SUBJECT: SUPPLEMENT IN RESPONSE TO DATA ADEQUACY
COMMENTS ON THE APPLICATION FOR CERTIFICATION FOR
THE SUN VALLEY ENERGY PROJECT (05-AFC-03)

In accordance with the provisions of Title 20, California Code of Regulations, Valle del Sol Energy, LLC hereby submits this document titled *Supplement in Response to Data Adequacy Comments on the Application for Certification for the Sun Valley Energy Project (05-AFC-03)*. The Sun Valley Energy Project is a 500 megawatt, natural gas-fired power plant to be located near Romoland, Riverside County, California.

Sun Valley Energy Project

(05-AFC-03)

Power Flow Diagrams

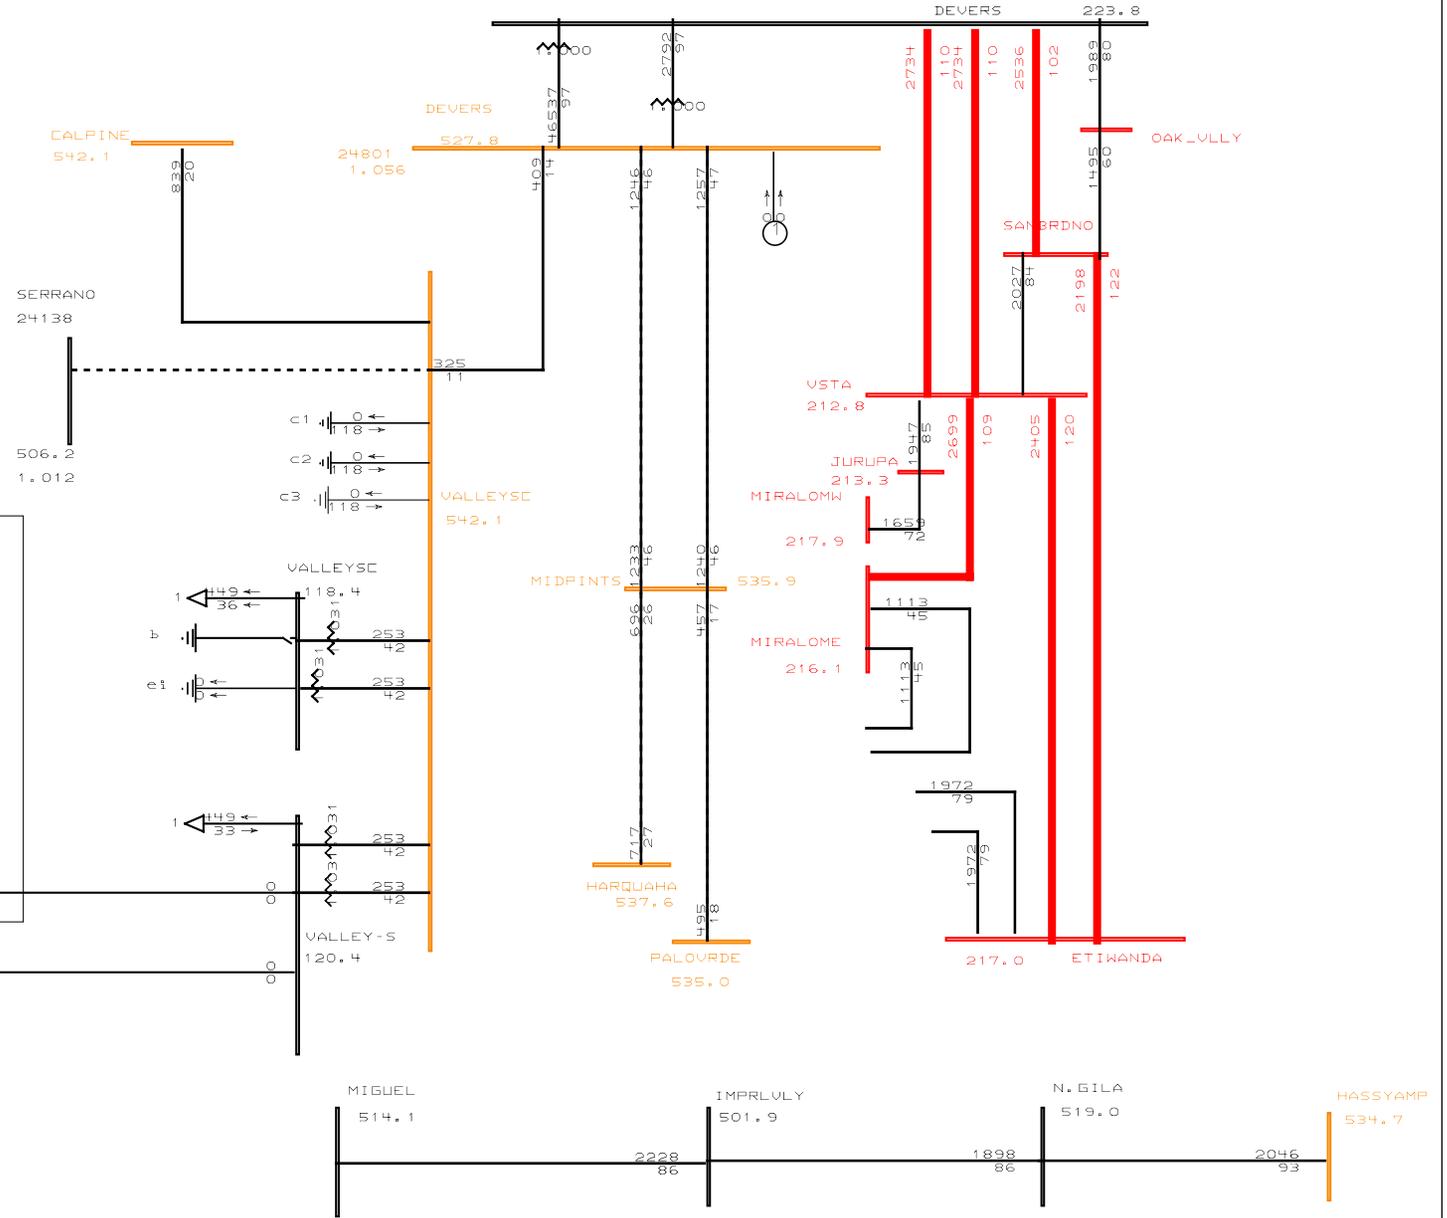
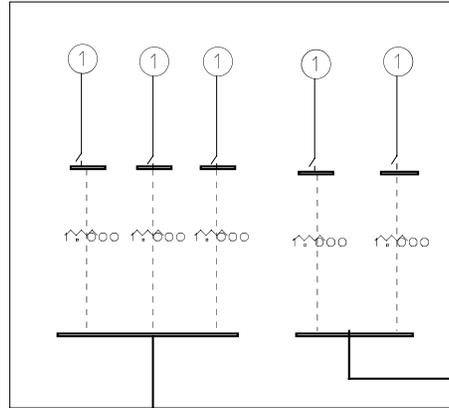
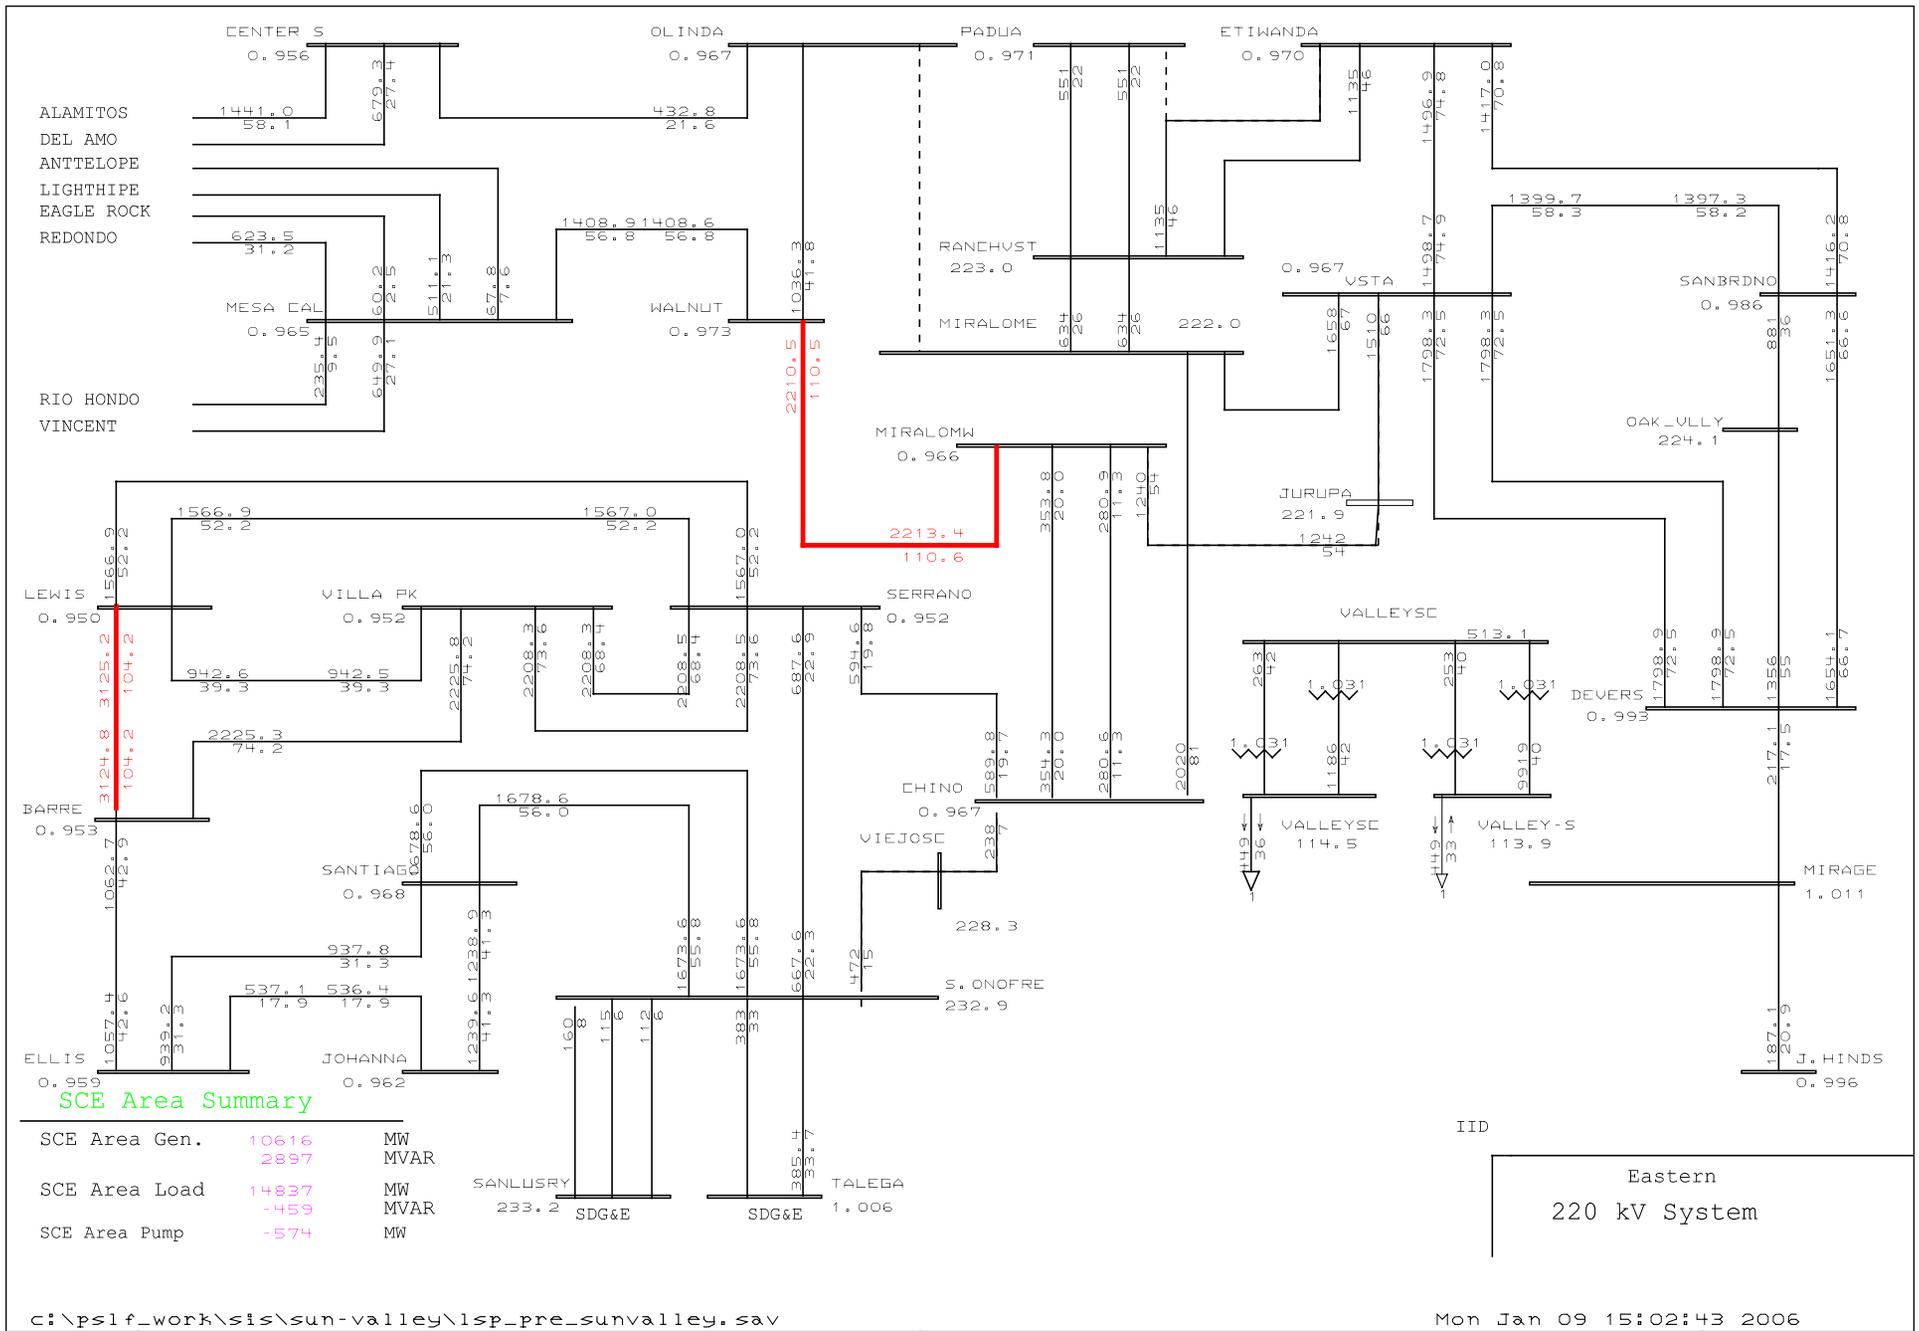
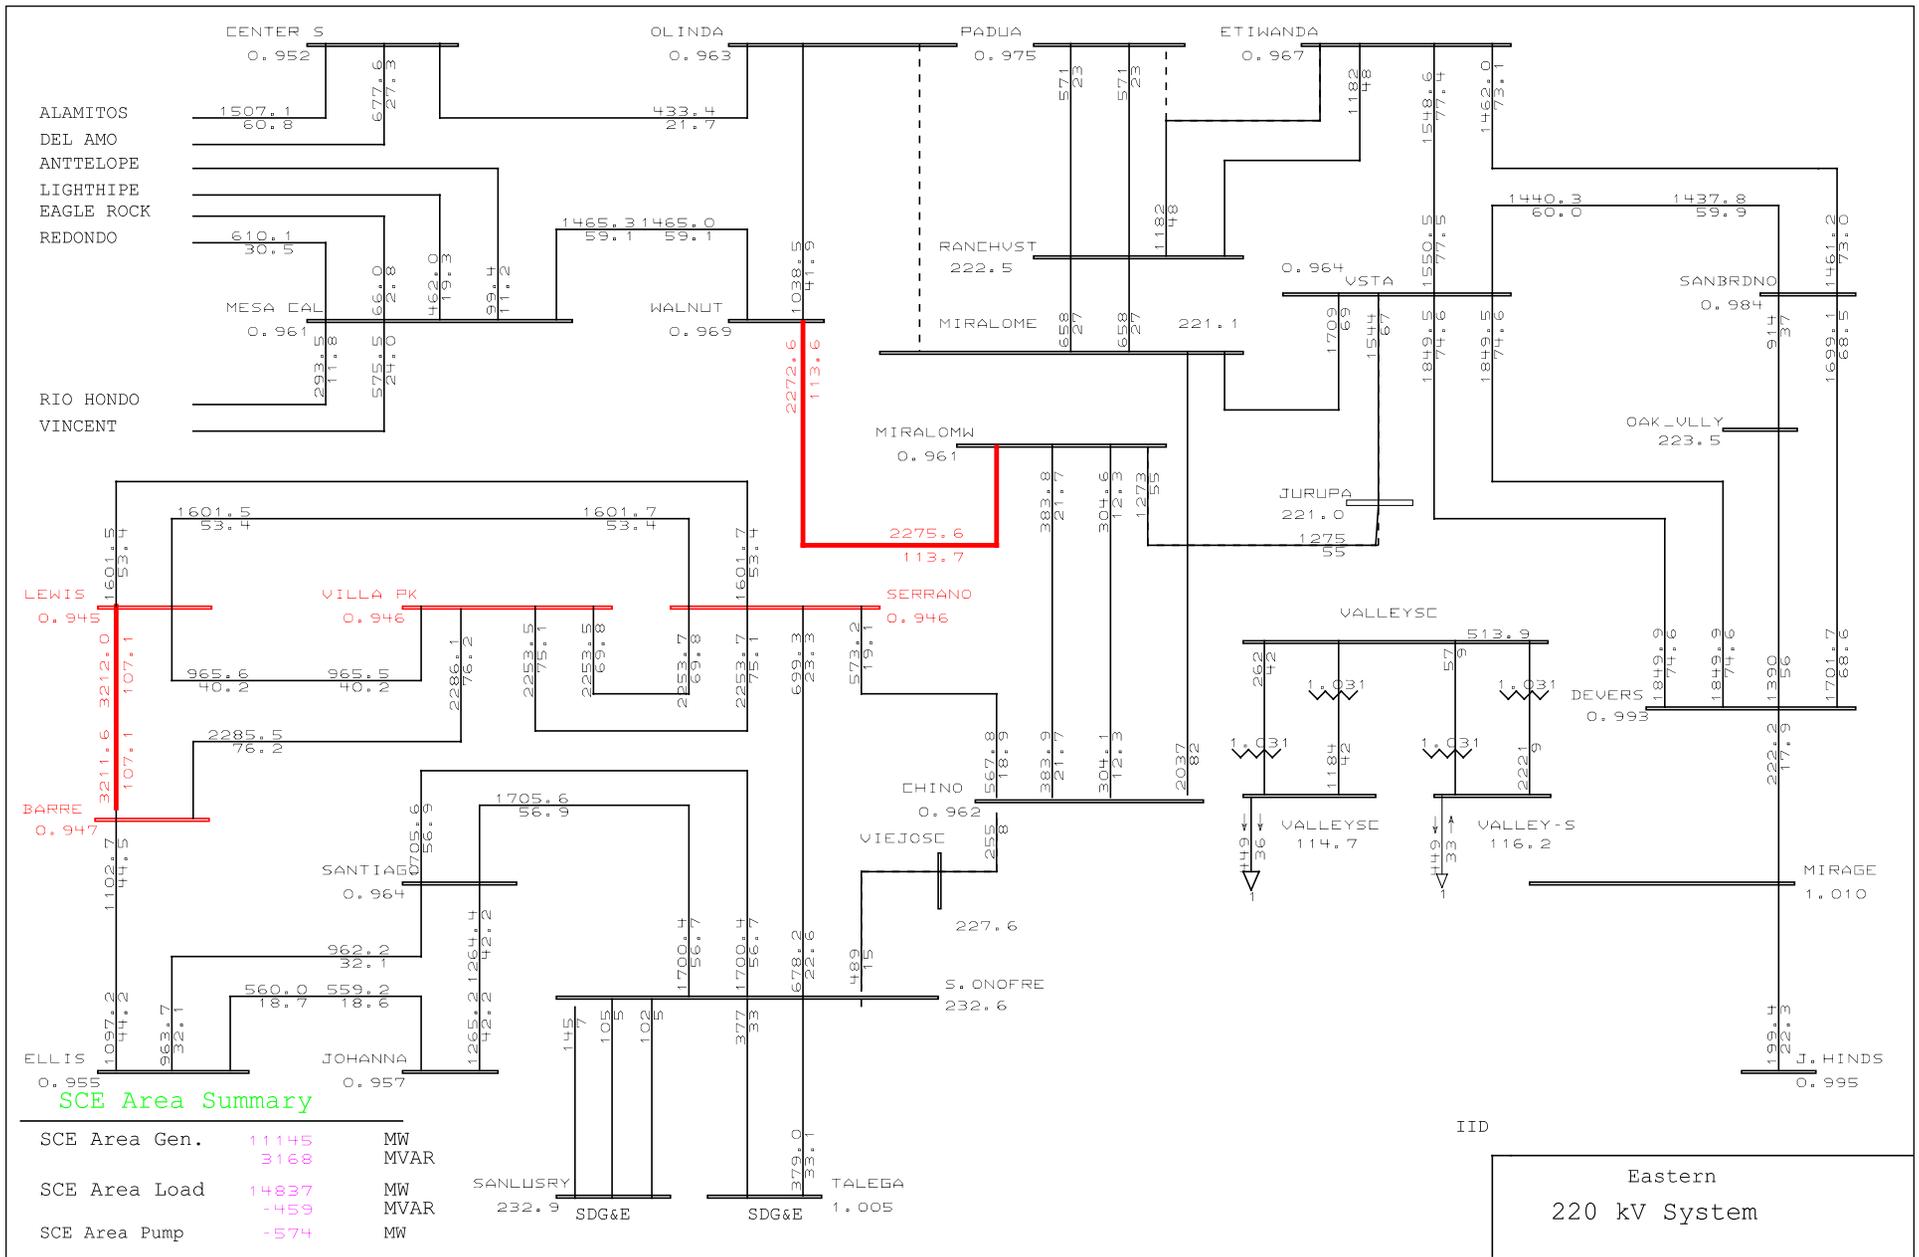
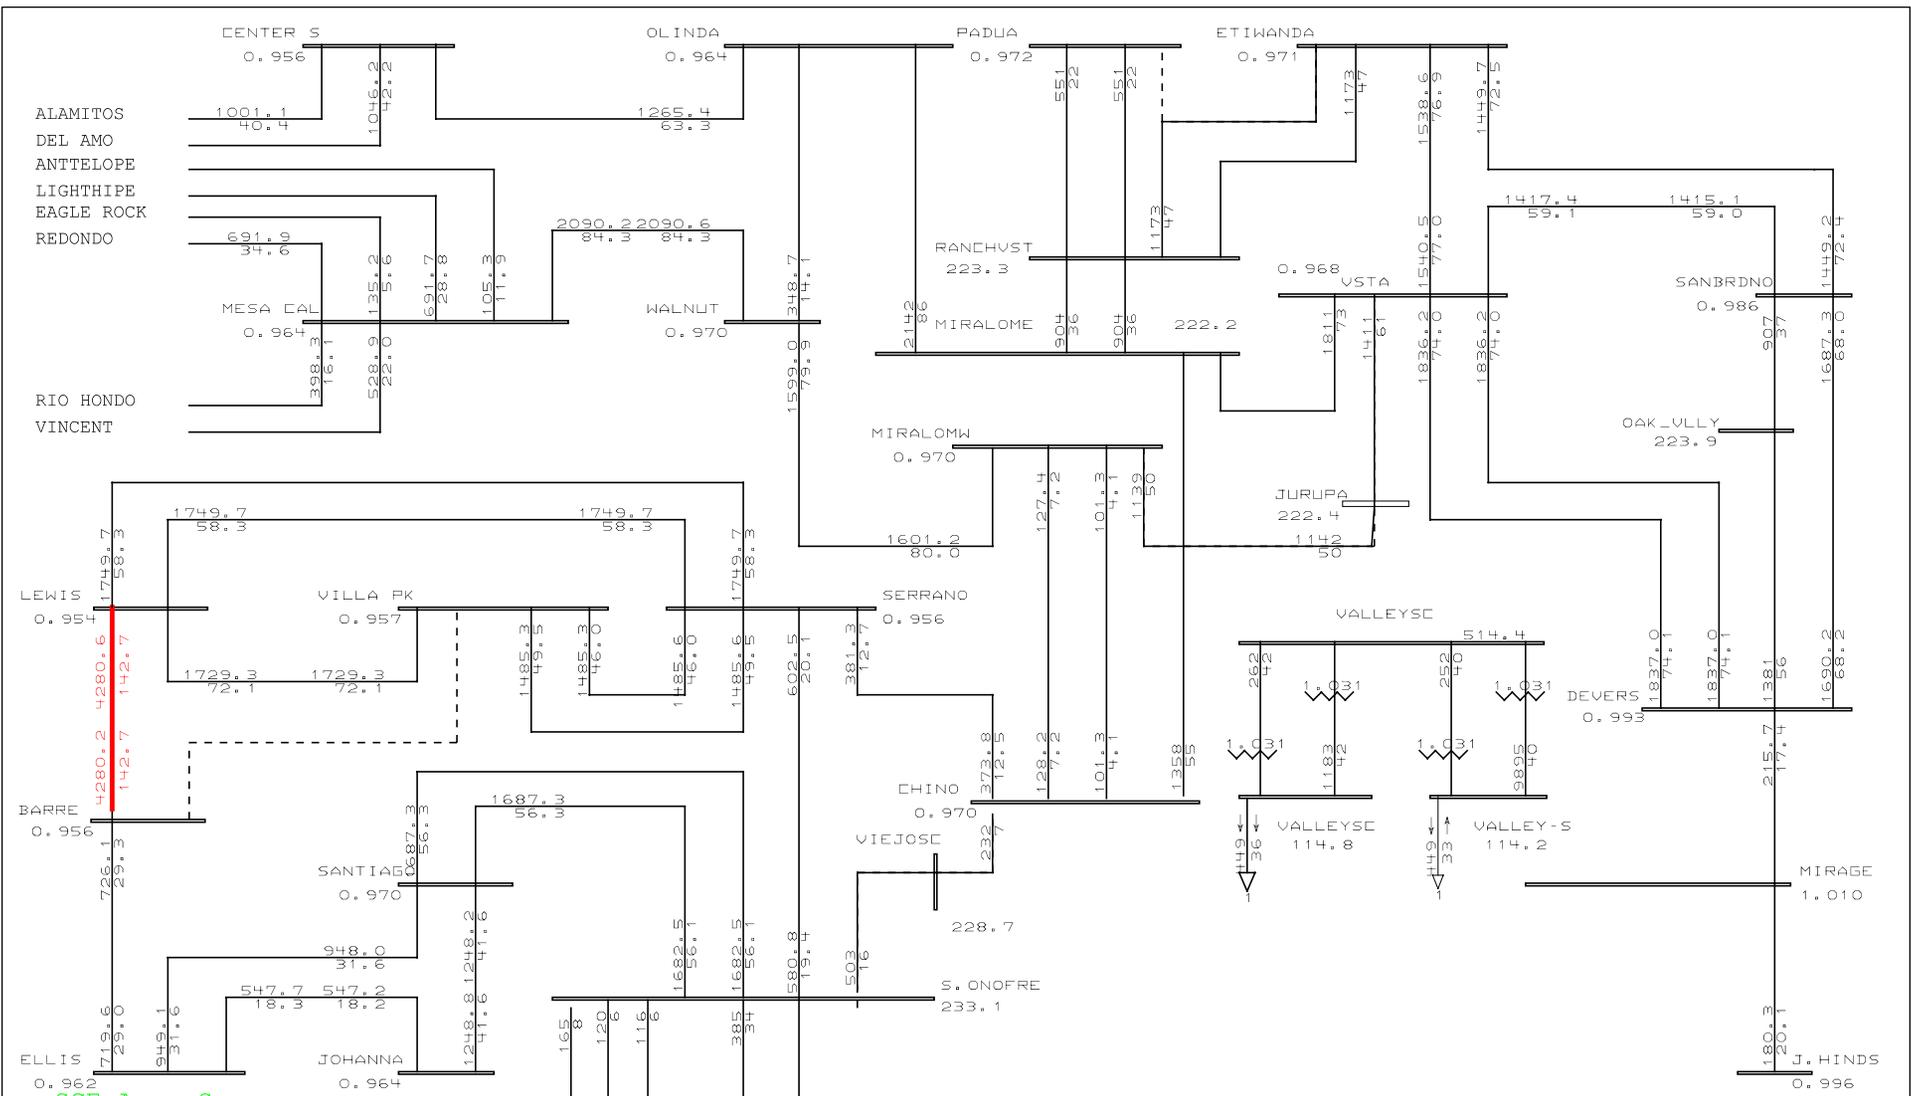
Provide power flow diagrams (MVA, % loading & P. U. voltage) for all N-1 and N-2 contingencies where overloads or voltage violations appear.

Response – Power flow diagrams for cases for which the SVEP would aggravate existing transmission system overloads are attached.
